Downtown West

Design Standards
and Guidelines
Errata

April 15, 2021

FIGURE 1.8: DWDSG framework plan

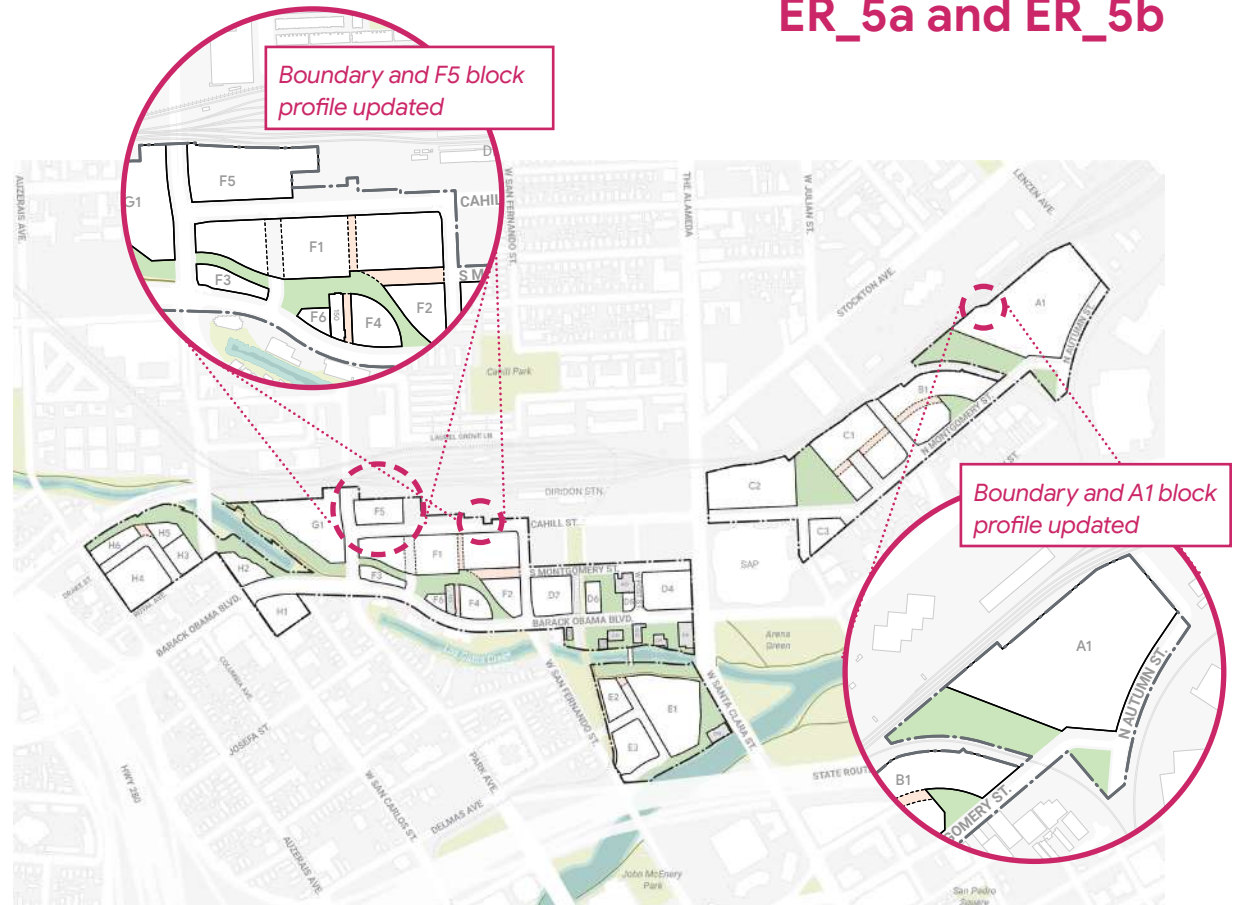
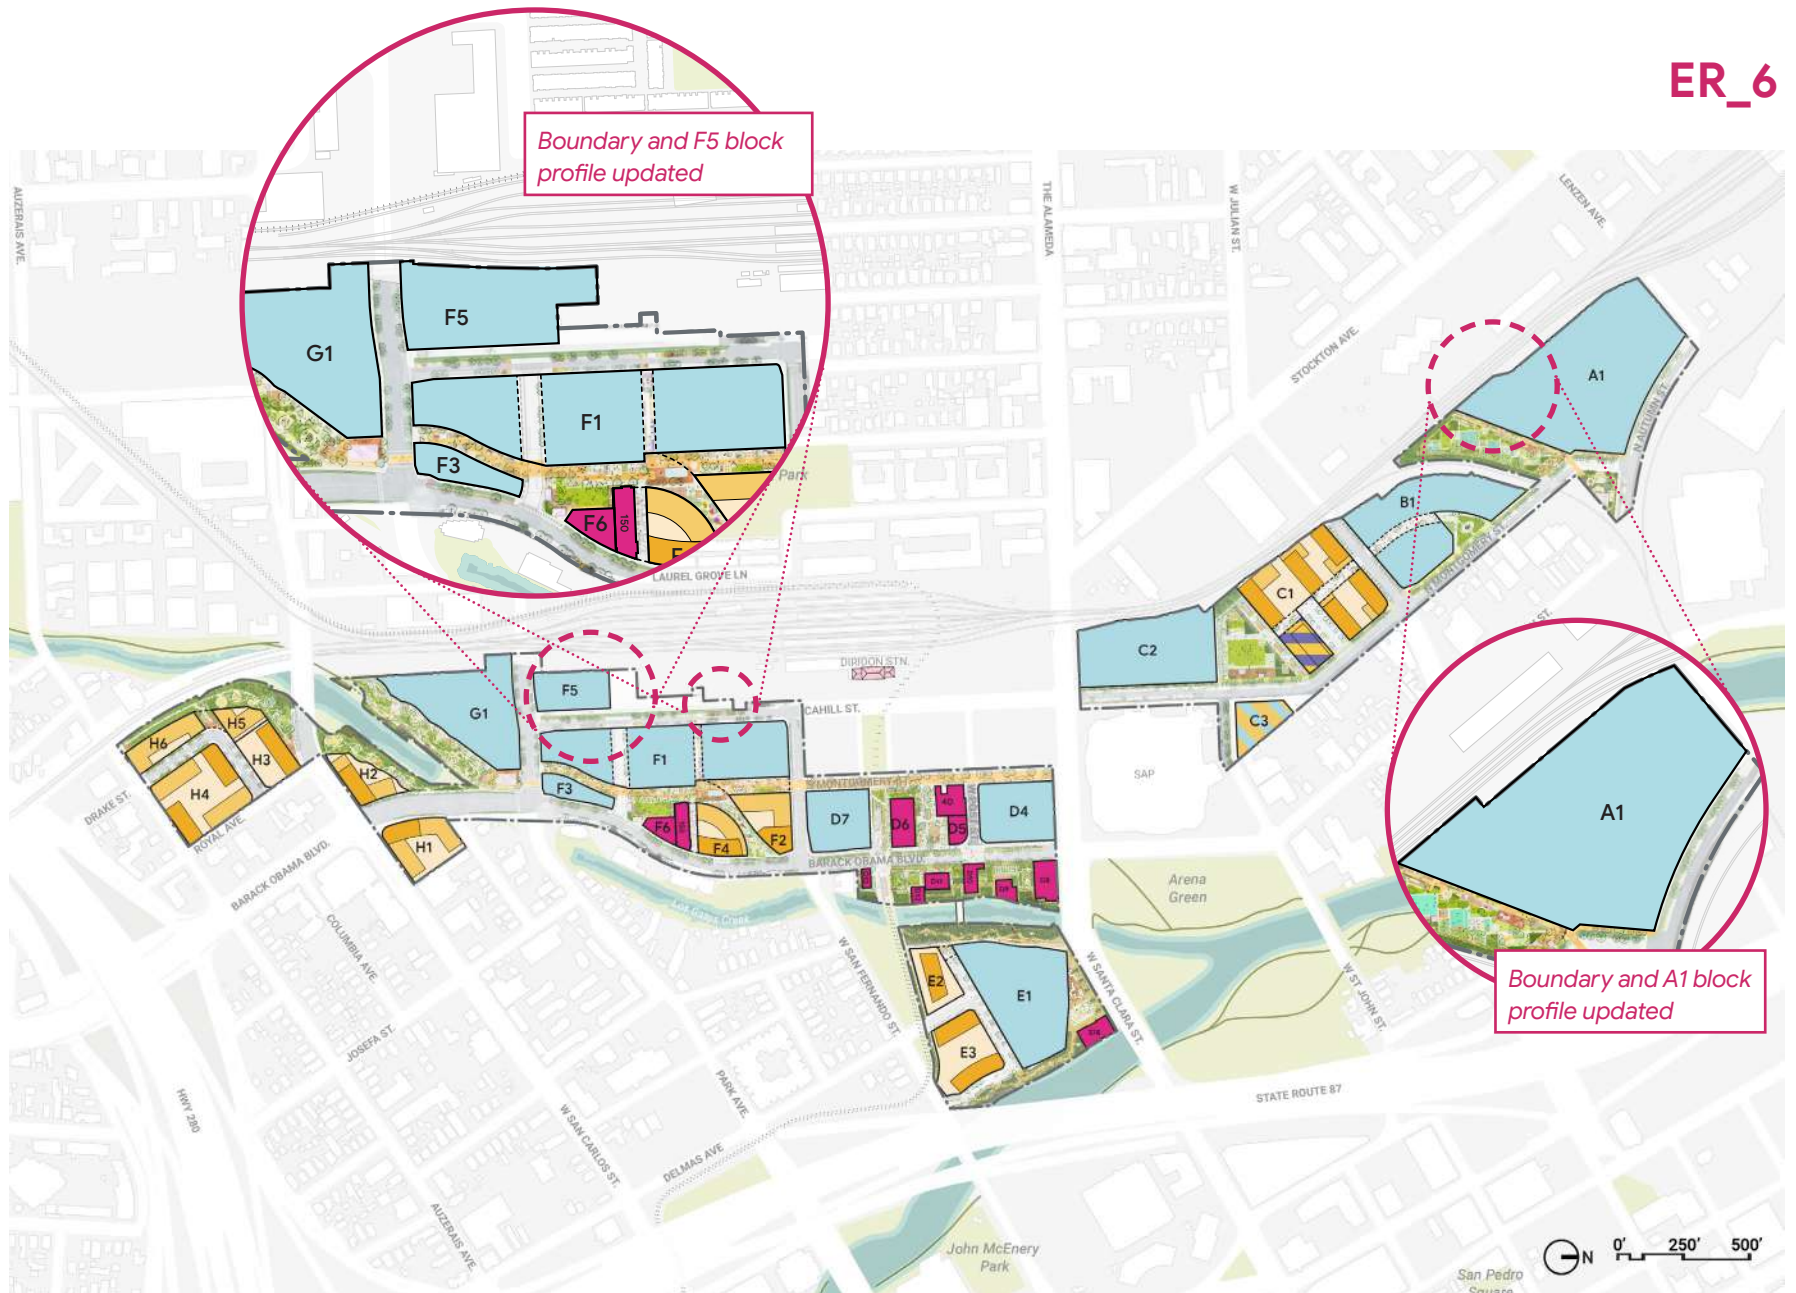
ER_5a	21	Document Overview	Figure 1.8	Site boundary and block profile changes at F5 and A1
ER_5b	21	Document Overview	N/A	The standards and guidelines in the DWDSG permit a limited range of land uses, massing, and circulation options, which may result in a block plan that differs from the DWDSG framework plan. Refer to the Vesting Tentative Map and subsequent Final Maps for dimensioned lot boundaries.
ER_6	30	Project Vision	Figure 2.2	Site boundary and block profile changes at F5 and A1
ER_7	49	Land Use	Figure 3.2	Site boundary and block profile changes at F5 and A1
ER_8	52	Land Use	Figure 3.3	Site boundary and block profile changes at F5 and A1 and southern infrastructure zone boundary extension
ER_9	56	Land Use	Figure 3.6	Site boundary changes and removal of non-building elements identified for demolition
ER_10a	71	Open Space	S4.5.2	“A minimum of 4.80 acres of the approximately 15 total acres of Project open space shall be City-dedicated open space, and shall, at minimum, meet the total acreages shown for Los Gatos Creek Multi-Use Trail and City-dedicated parks identified in Table 4.1: ”

The standards and guidelines in the DWDSG permit a limited range of land uses, massing, and circulation options, which may result in a block plan that differs from the DWDSG framework plan.

FIGURE 3.6: Demolition and retention plan

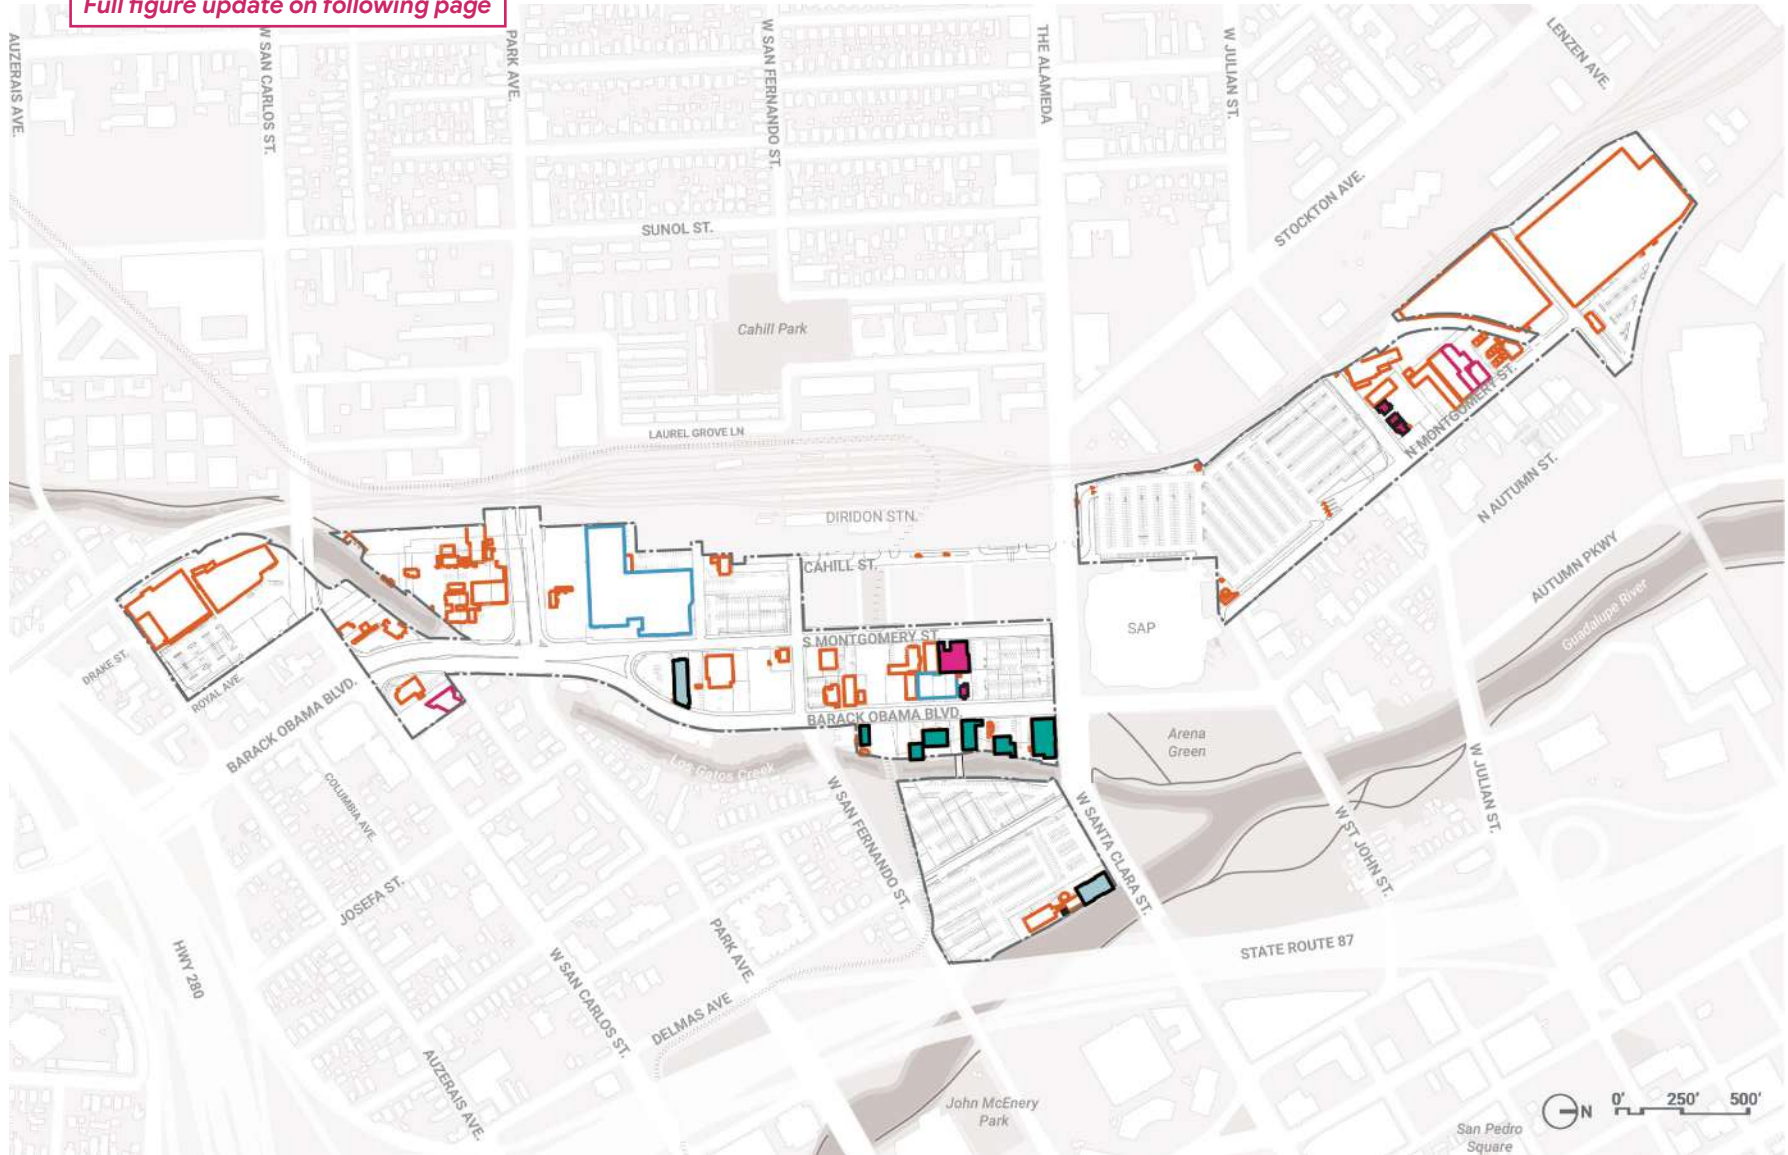
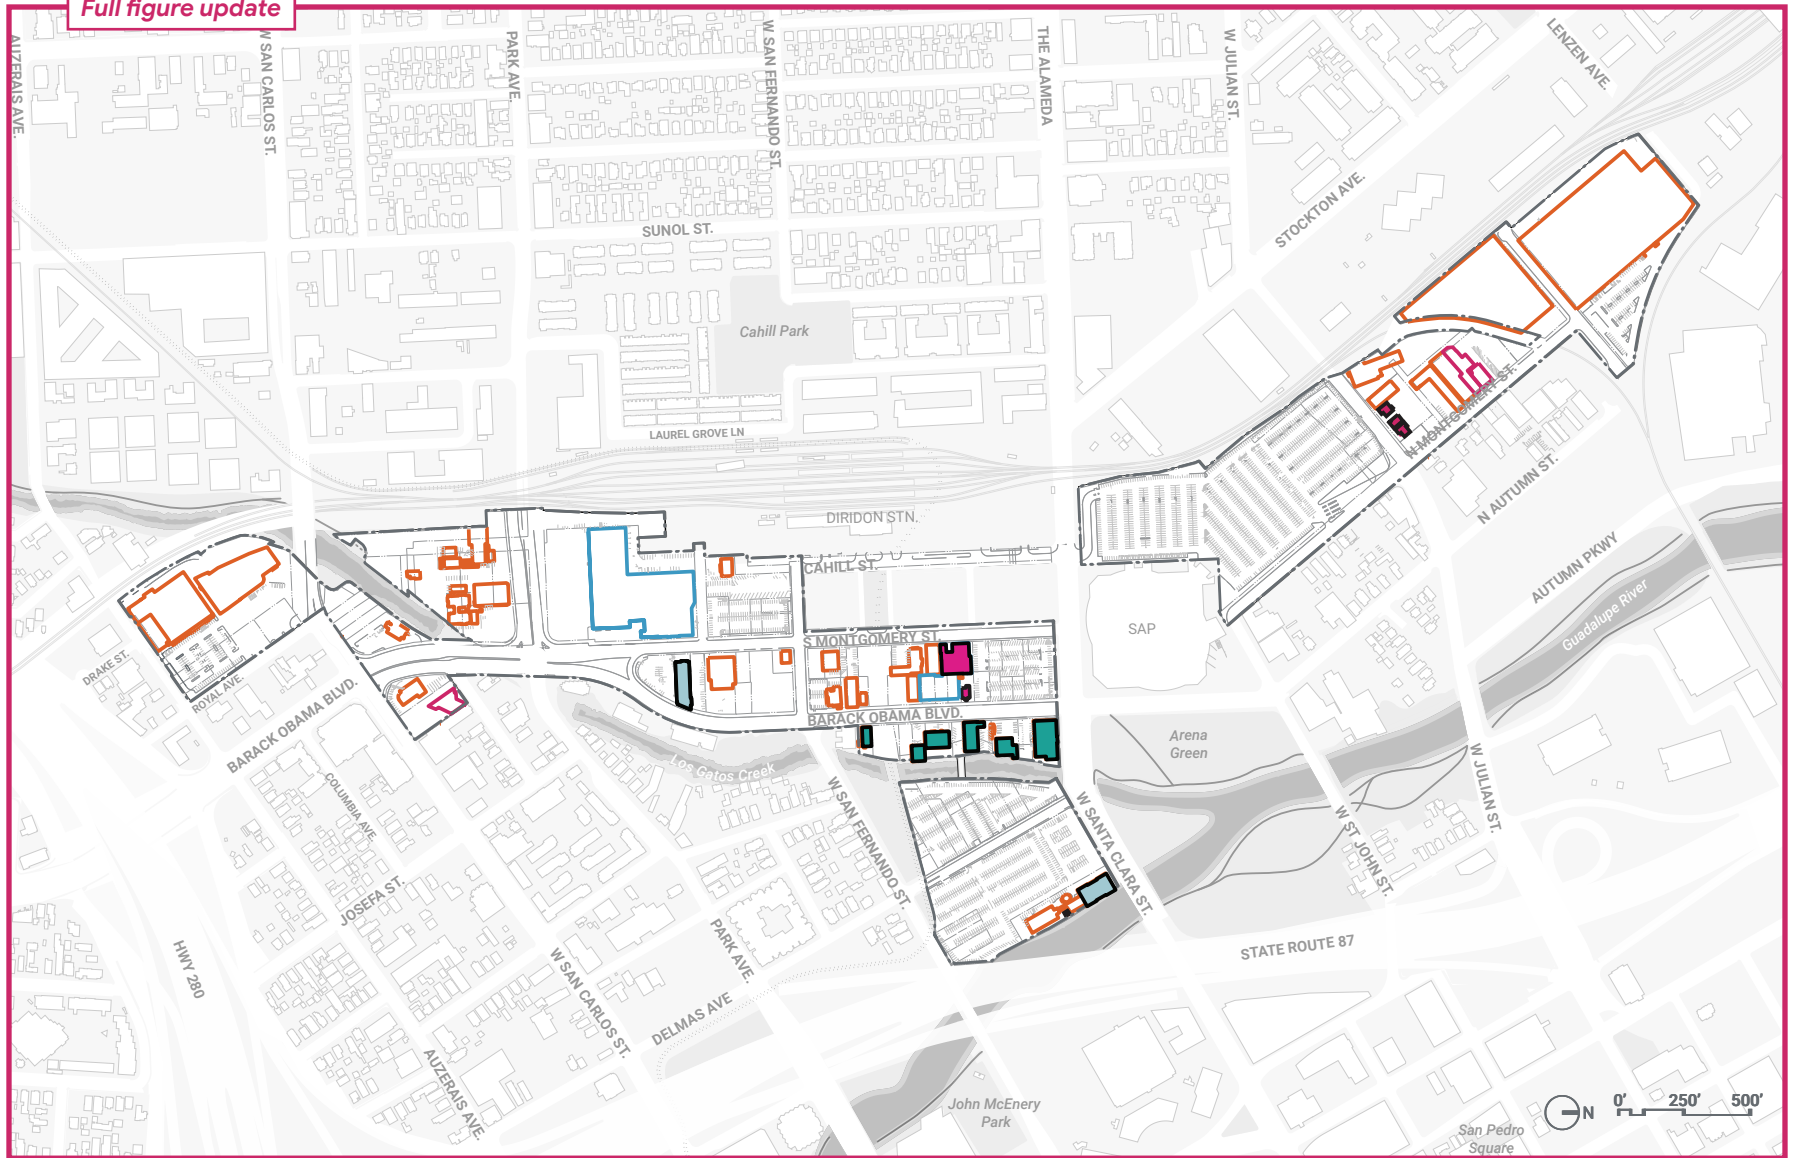
Full figure update on following page

Full figure update

FIGURE 4.49: Illustrative plan of Gateway to San José

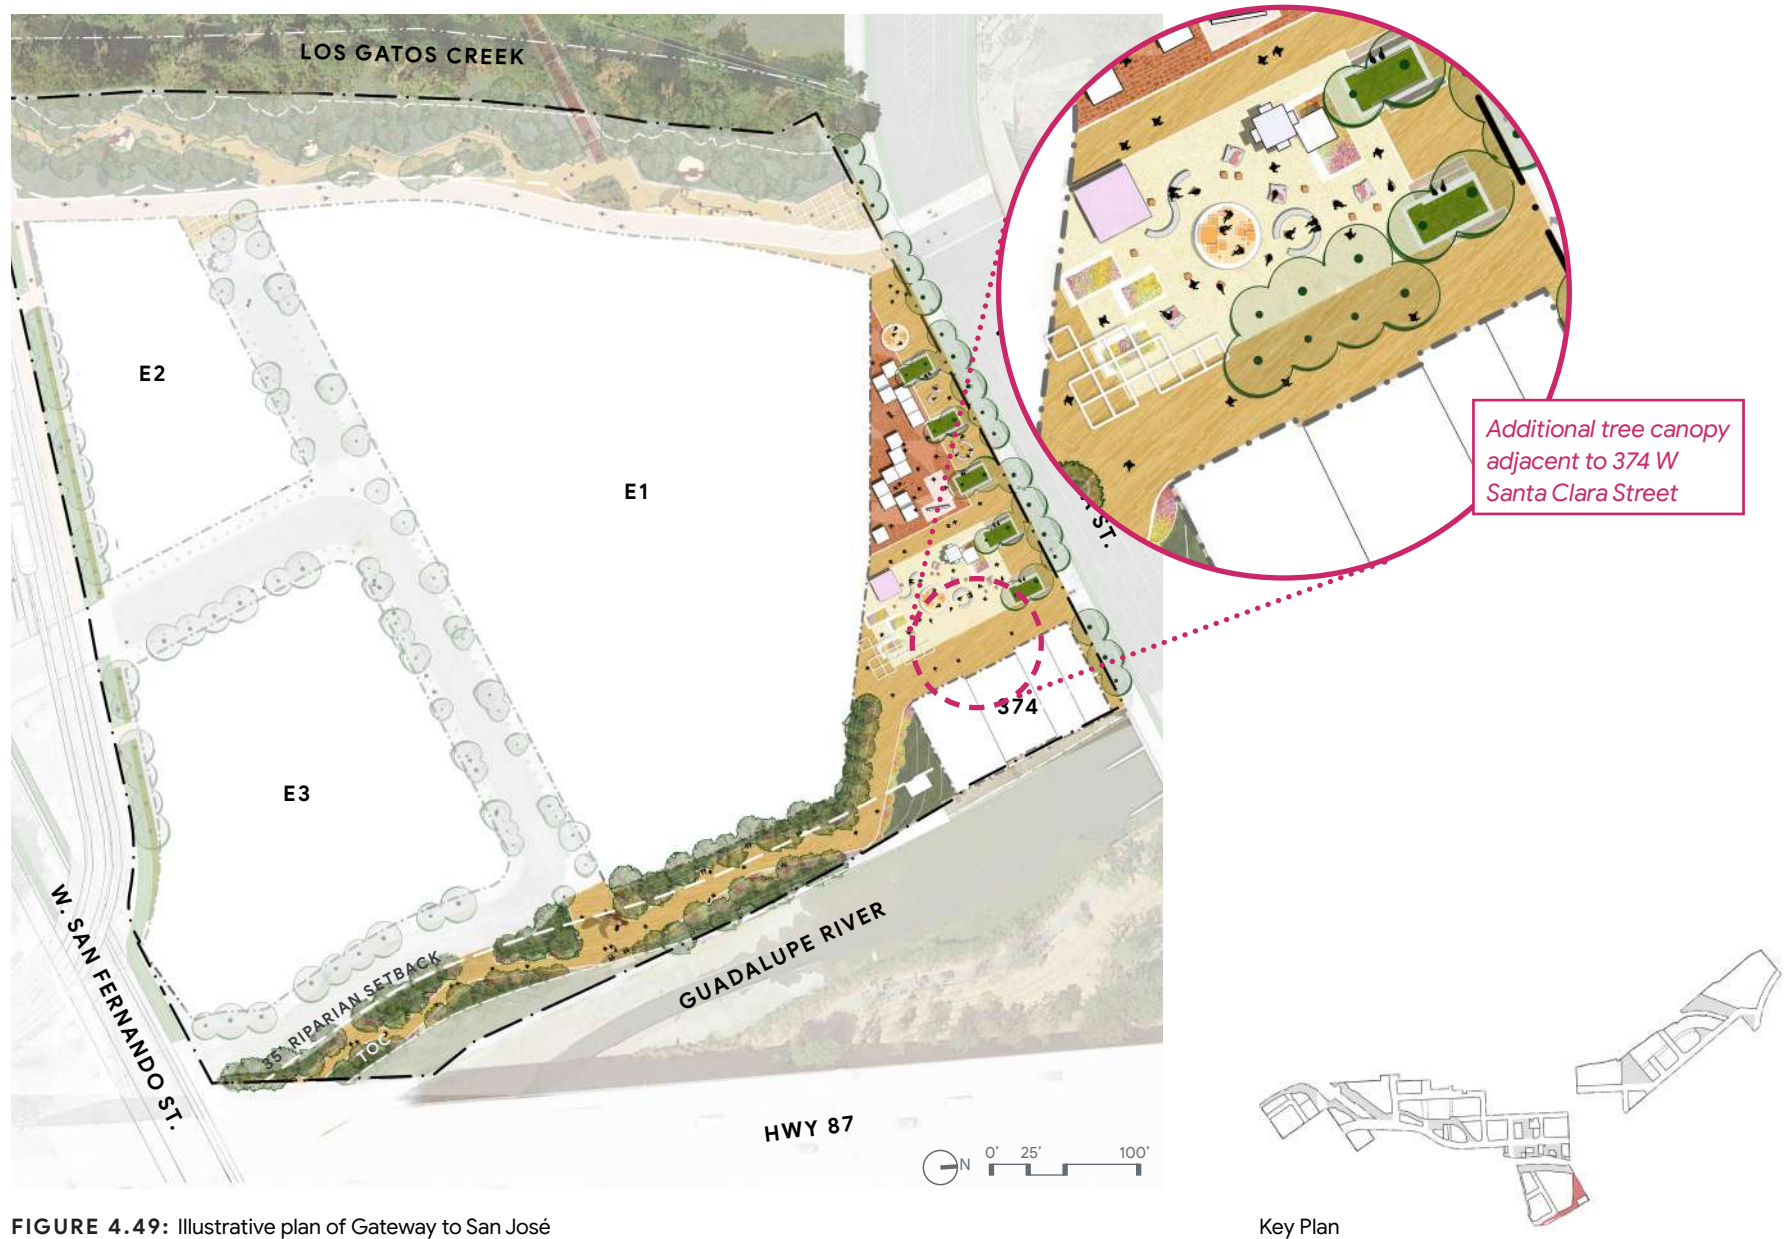
ERRATA ID	DWDSG PAGE NUMBER	DWDSG CHAPTER	DWDSG CONTENT	DESCRIPTION OF UPDATES
ER_10c	134	Open Space	Figure 4.49	Additional tree canopy adjacent to 374 W Santa Clara Street
ER_10d	136	Open Space	Figure 4.50	Additional tree canopy adjacent to 374 W Santa Clara Street
ER_10e	148	Open Space	Figure 4.60	Additional tree canopy adjacent to 374 W Santa Clara Street
ER_11	150	Open Space	Table 4.15	Addition of “California Hazelnut, <i>Corylus cornuta</i> Marsh. var. <i>californica</i> ” to plant species list
ER_12	156	Open Space	S4.25.4	“Serviced and unserviced pavilion structure that use glazing as a material shall provide glazing units with visible light transmittance below 60 percent which shall not count toward the required transparent area. Existing structures that are relocated as pavilions shall be exempt from transparency requirements. ”
ER_13	156	Open Space	S4.25.6	“Public restrooms, park maintenance and storage facilities, and park management offices shall be permitted supportive structures for open spaces active uses; see Section 3.1. No single park maintenance structure shall exceed 1,500 square feet in interior area. Park maintenance structures shall not exceed 20 feet in height above finished grade as measured to top of roof. Park maintenance structures are permitted in either the open space or the interior of an adjacent building, new development blocks, or other space outside of street right-of-way. If provided as a standalone structure in the open space, the structure size cannot exceed the maximum cover limit described in Table 4.16.”
